# R & E Grant Application 19-21 Biennium

Project #: 19-016

## *Port of Bandon ADA Fishing Pier*

## ***Internal Review Results***

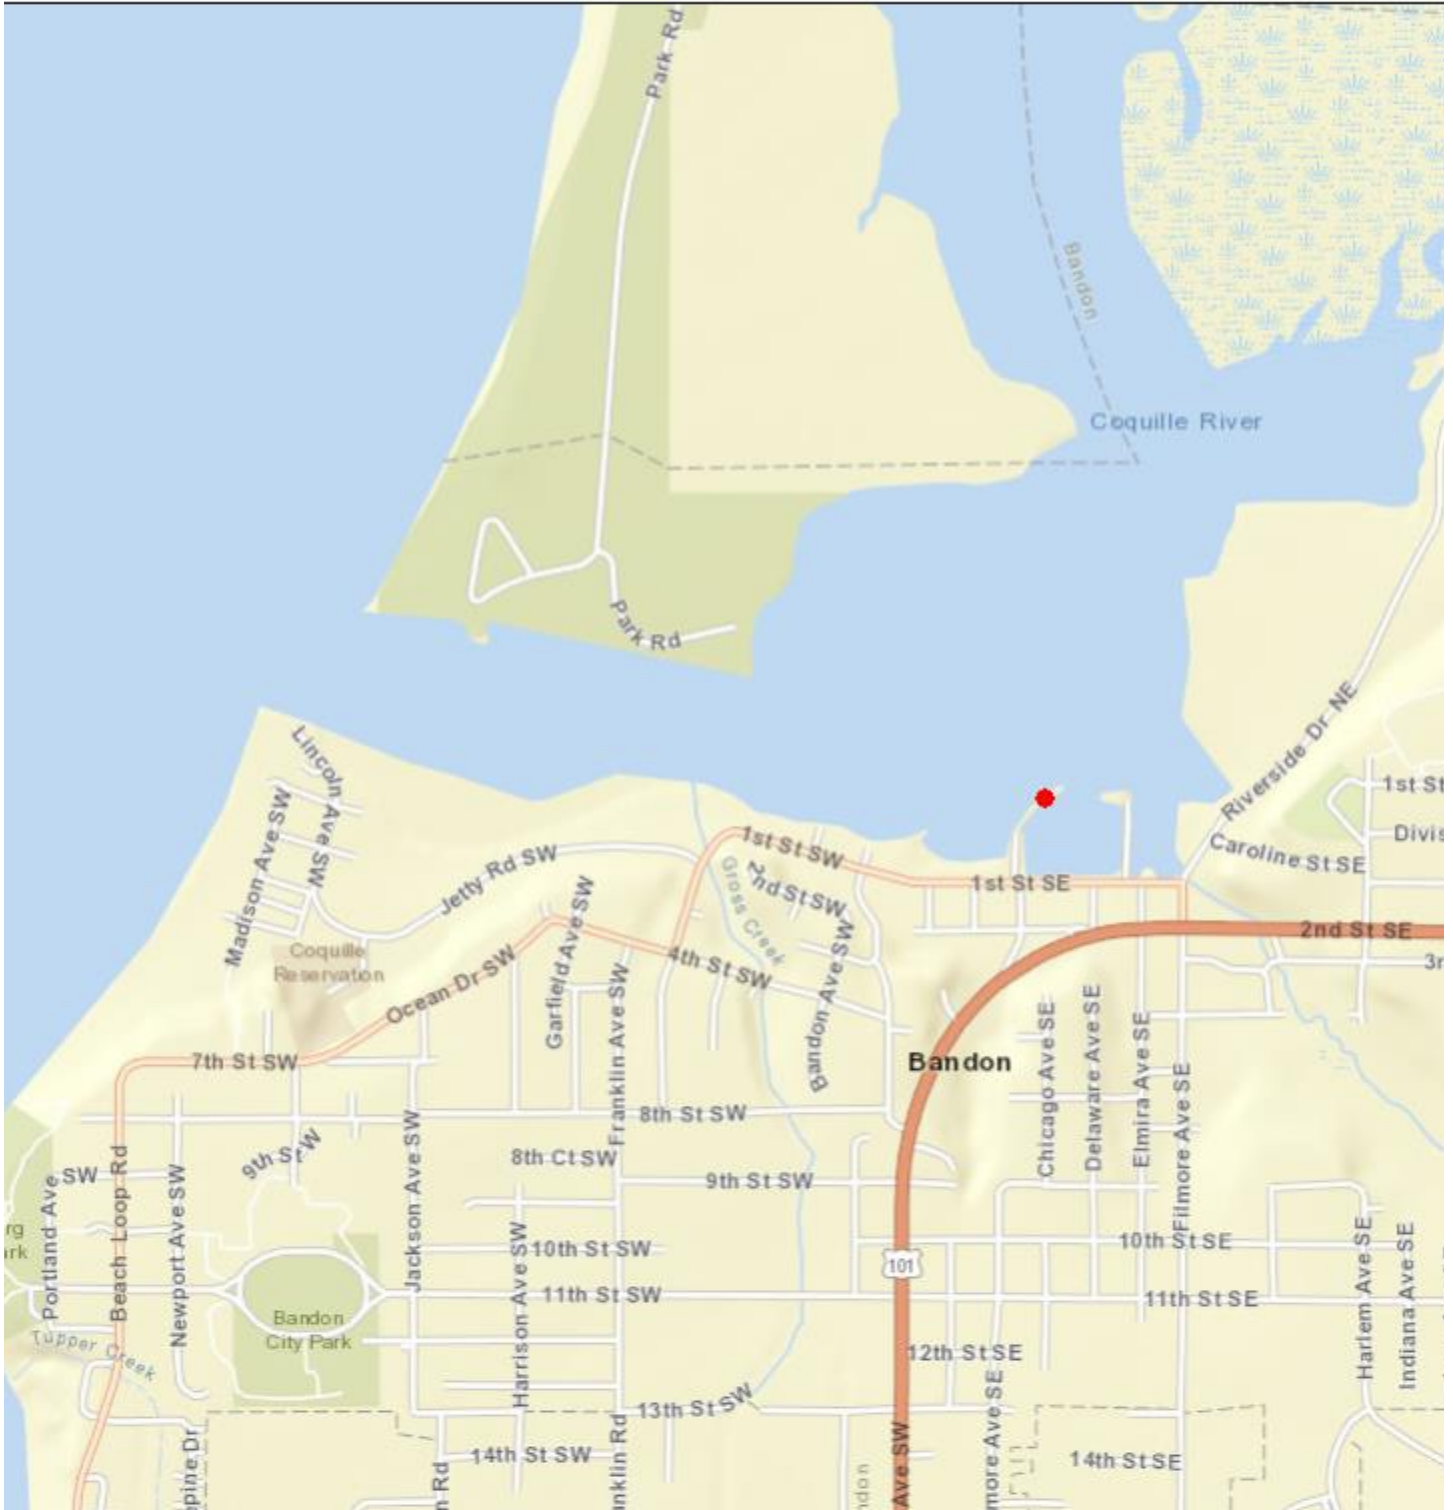
*Please describe how the proposed solution will meet accessibility standards from where the person parks all the way to the point at which they are using the dock. Is there ADA parking available at this site? Does the number of spots and the space required meet the ADA standards for parking?*

We will include in this project additional ADA parking spaces adjacent to the pier entrance on the high dock. That area is used for random parking now and has the room to designate the ADA spaces. This would be in addition to the spaces the Port already has on the nearby boardwalk.
